**Appl. No.** : **09/847,759**  
**Filed** : **May 2, 2001**

### REMARKS

### **Corrections in Response to the Notice of Non-Responsiveness Dated September 5, 2008**

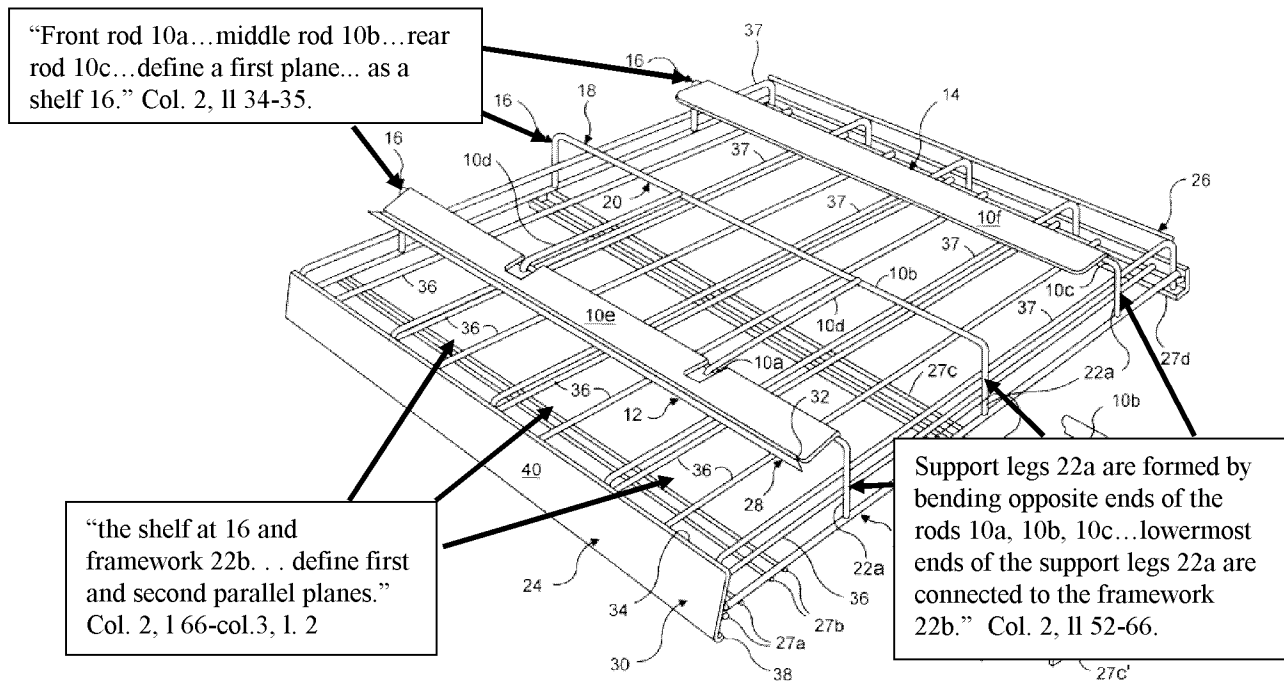
The Outstanding Notice indicates that the Amendment filed May 2, 2008 was not fully responsive because the text of Claim 50, which is a new claim, included the bracketed letters “[like]”, the use of the claim identifier “(New)” for Claim 62, and for failing to include sufficient explanation for support for the term “direct” added to Claims 68 and 69.

With regard to support for the term “direct” added to Claims 68 and 69, Applicant respectfully directs the Examiner to Figure 1, reproduced below, and the previously identified text at column 2 lines 52-66 of the present Application.

Applicant submits that the disclosure of the support legs 22a firstly, being formed by bending the ends of the rods 10a, 10b, and 10c, and being connected to the framework 22b at their lower ends, fully supports the claim language “at least one support directly connecting as least the front rod member and the framework” as recited in Claims 68 and similarly recited in Claim 69.

Applicant submits that these disclosures from the specification of the present Application are entirely sufficient to serve as an “explanation of support” as required by MPEP § 1453 paragraph (V)(D).
